CONSTRUCTION VALUE ENGINEERING CONCEPT PROPOSAL
MISSOURI DEPARTMENT OF TRANSPORTATION

Contract ID 070928-X01 Job No. J0P0928
County Madison Route 67 Original Bid Cost \$37,597,624.33
Contractor Emery Sapp & Sons By Matthew Oesch
Designed By Jesse Hinton Phone (573) 489-9216
VECP 09-50

**RE: Value Engineering Proposal 7,
Alternative Alignment for 865+00-1035+00
Rte. 67, Madison County,
Job No. J0P0928**

MADISON CO RT 67
 STA 865+00 TRANSITION

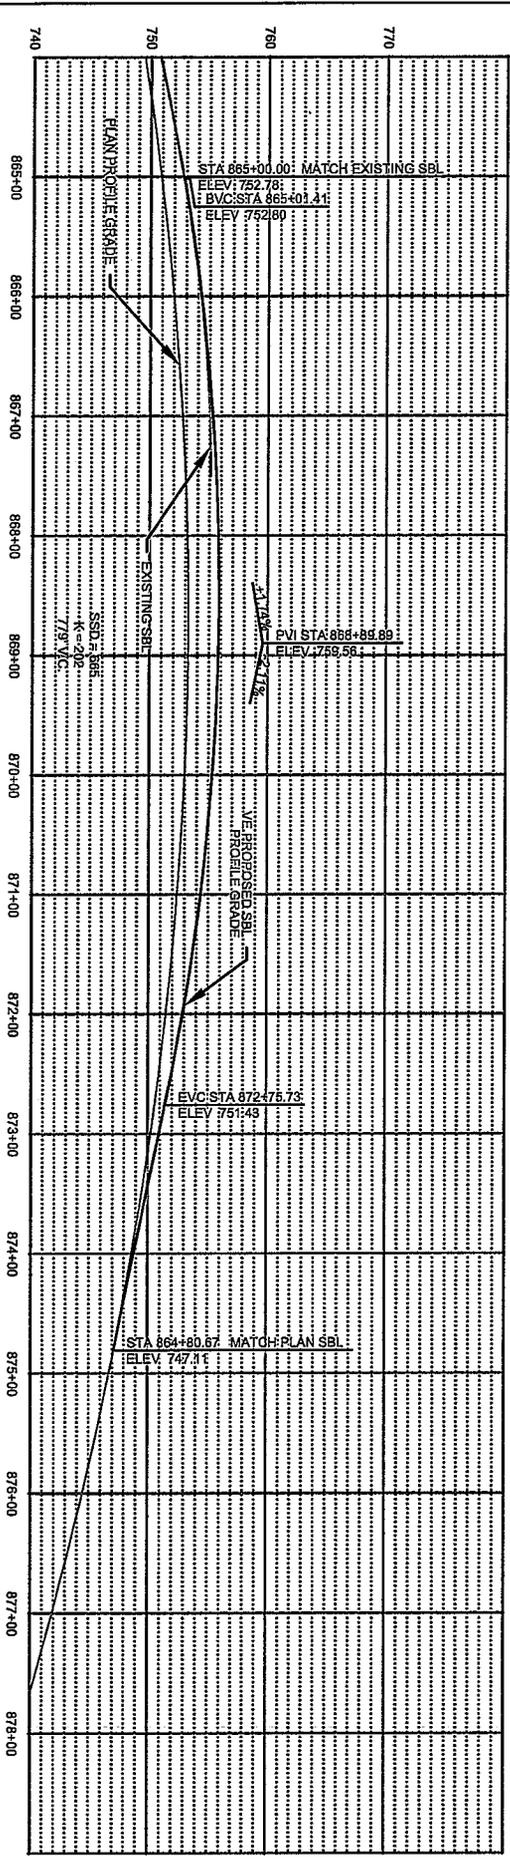
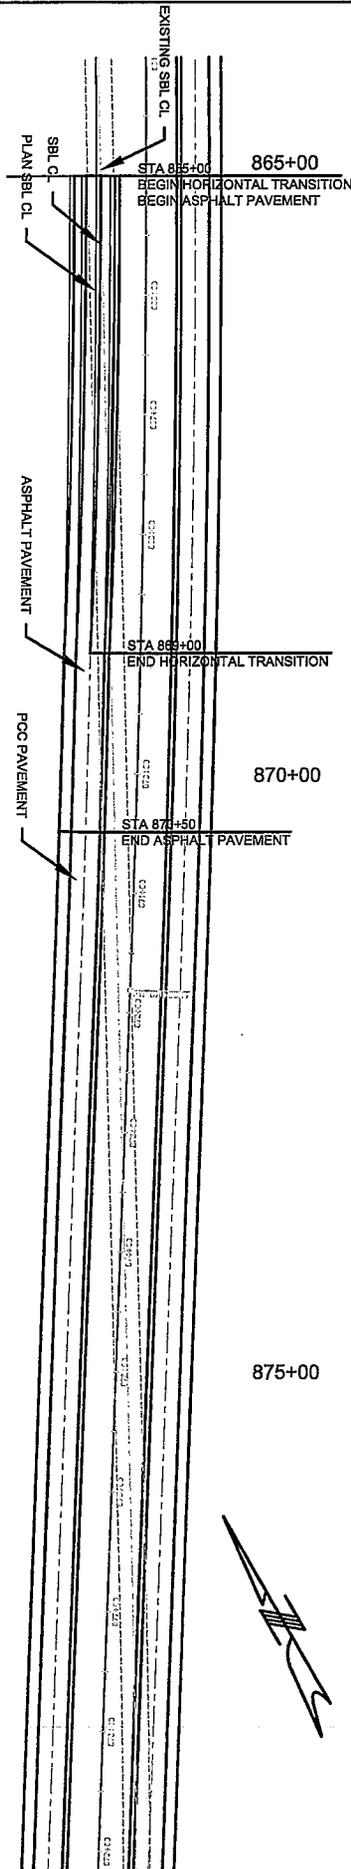
The profile grades for the new mainline fail to match that of the existing highway at both tie-in locations. At Sta 865+00, a vertical difference of over 1.5 feet exists between the new profile and existing profile. The horizontal alignment is off by over two feet at the Sta 865+00 tie-in. At Sta 1035+00, the design profile requires the new roadway to be over three feet higher than the existing top of pavement.

For the tie-in at Sta 865+00 the profile will need to be adjusted in order for the new SBL to tie-in cleanly with the existing highway. The vertical curve will need to be adjusted to the following: PVI 868+89.89, Elevation 759.56, Up Station Slope +1.74%, Down Station Slope -2.11%, SSD = 665, K=202, and 779 VC. The difference in horizontal alignment has been adjusted out from Sta 865+00 to Sta 869+00. Additional fill will be needed in order to raise the grade to meet new vertical curve and match the existing roadway. The fill will be placed prior to Stage 1 paving. Stage 1 paving will be completed on the SBL from Sta 872+00 to Sta 1025+00 at full width and depth using machine pour. Full depth 9 inch PCCP pavement and Type 5 Base will then be hand placed from Sta 865+00 to Sta 872+00 tying the new SBL into the existing highway. The hand placed pavement will slowly taper out wider as the alignment shifts away from the existing highway. Then Type 5 Base and 9 inch PCCP will be hand placed along the inside shoulder from Sta 865+00 south tapering in as the alignment shifts into and across the existing pavement. The inside shoulder will taper from approx 2 ft to 0 ft maintaining a 13 foot wide lane as the shoulder merges into the existing roadway.

Doweling will be used along the edge of the existing concrete on both sides to securely join the new concrete pavement to the existing roadway. Edge treatment will be used where necessary while preparing for paving to insure motorist safety. Once the concrete wedging is completed, 3 inch of BP-1 will be placed 26 feet wide from Sta 865+00 to Sta 870+50 creating a smooth seamless tie-in of the joint between the roadways. Full depth saw cuts will be used along the inside shoulder to cleanly remove the remaining portions of existing US 67 that require demolition in order to perform median grading. A3 shoulders and Daylight of Aggregate Base will be completed from Sta 865+00 to Sta 872+00 as well. Portions of existing US 67 may be left under the inside 3 foot A3 shoulder for added support. Flagging and traffic control will be used throughout the wedging process to insure safety of motorist and workers alike.

MADISON CO RT 67
STA 1035+00 TRANSITION

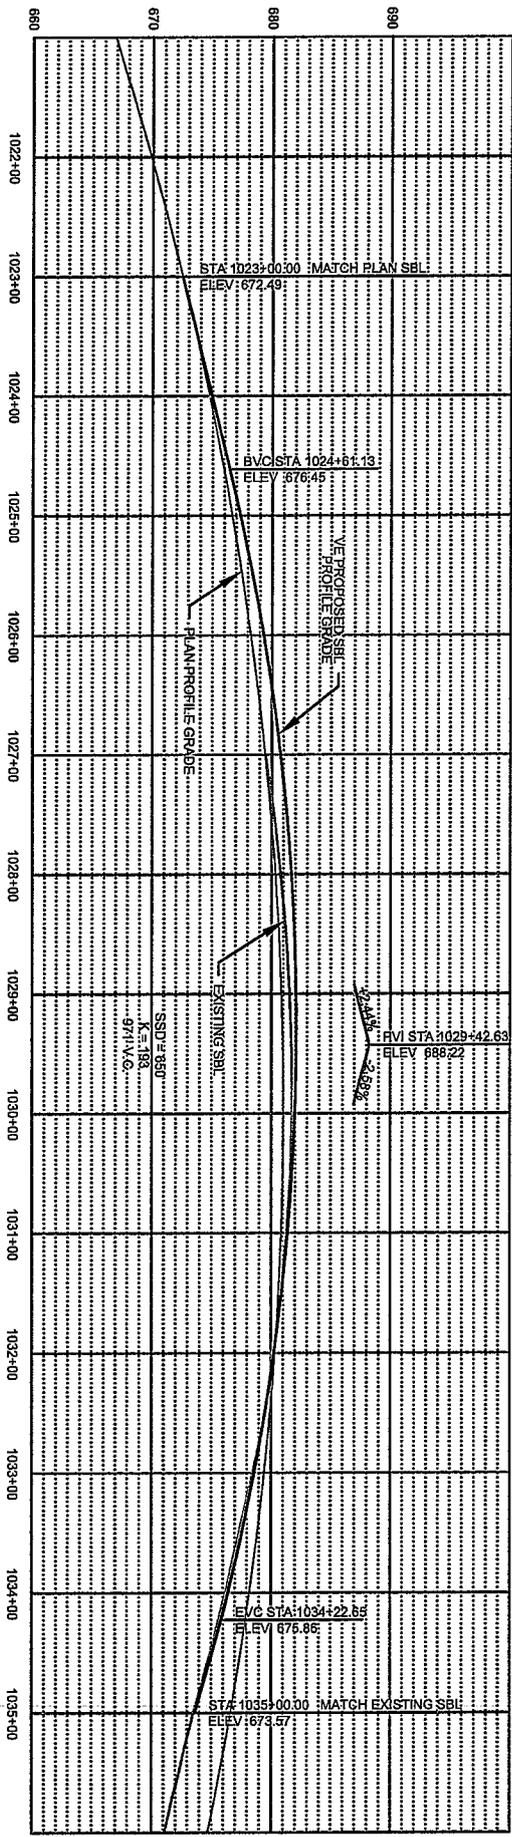
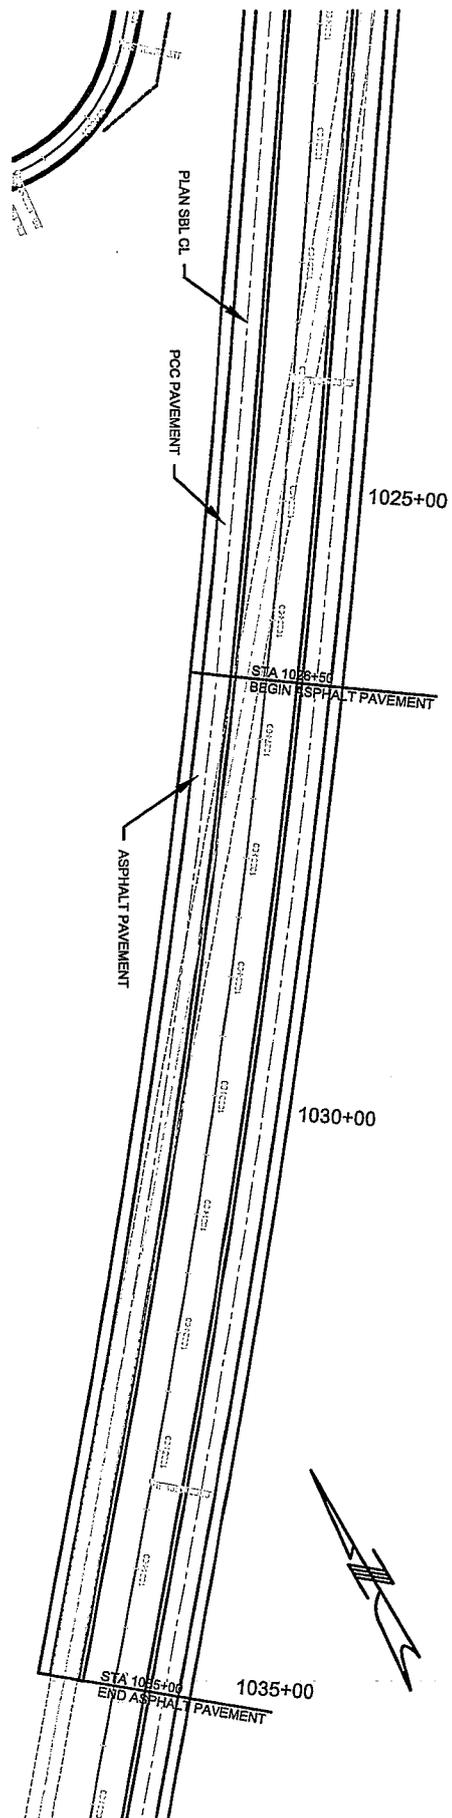
The tie-in at Sta 1035+00 will require profile adjustments as well in order to obtain a smooth tie-in with existing US 67. The vertical curve will need to be adjusted to the following: PVI 1029+42.63, Elevation 688.22, Up Station Slope +2.44%, Down Station Slope -2.58%, SSD = 650, K=193, and 971 VC. Additional fill will be needed in order to raise the grade to meet new vertical curve and

match the existing roadway. The fill will be placed prior to Stage 1 paving. Stage 1 paving will be completed on the SBL from Sta 872+00 to Sta 1025+00 at full width and depth using machine pour. Type 5 Base and 9 inch PCCP pavement will then be hand placed along the west side of existing US 67 from Sta 1025+00 to Sta 1035+00 tying the new SBL into the existing highway. Then Type 5 Base and 9 inch PCCP will be hand placed along the inside shoulder from Sta 1035+00 north tapering in as the alignment shifts into and across the existing pavement. The inside shoulder will taper from approx 2 ft – 0 ft maintaining a 13 foot wide lane as the shoulder merges into the existing roadway.

Doweling will be used on both side of the existing concrete to securely join the new concrete pavement to the existing roadway. Edge treatment will be used where necessary while preparing for paving to insure motorist safety. Once the concrete wedging is completed, 3" of BP-1 will be placed 26 ft wide from Sta 1026+50 to Sta 1035+00 creating a smooth seamless tie-in over the joint between the roadways. Full depth saw cuts will be used along the inside shoulder to cleanly remove the remaining portions of existing US 67 that require demolition in order to perform median grading. A3 shoulders and Daylight of Aggregate Base will be completed from Sta 1025+00 to Sta 1035+00 as well. A portion of existing US 67 (where the alignments intersect) may be left under the inside 4 foot A3 shoulder for added support. Flagging and traffic control will be used throughout the wedging process to insure safety of motorist and workers alike.
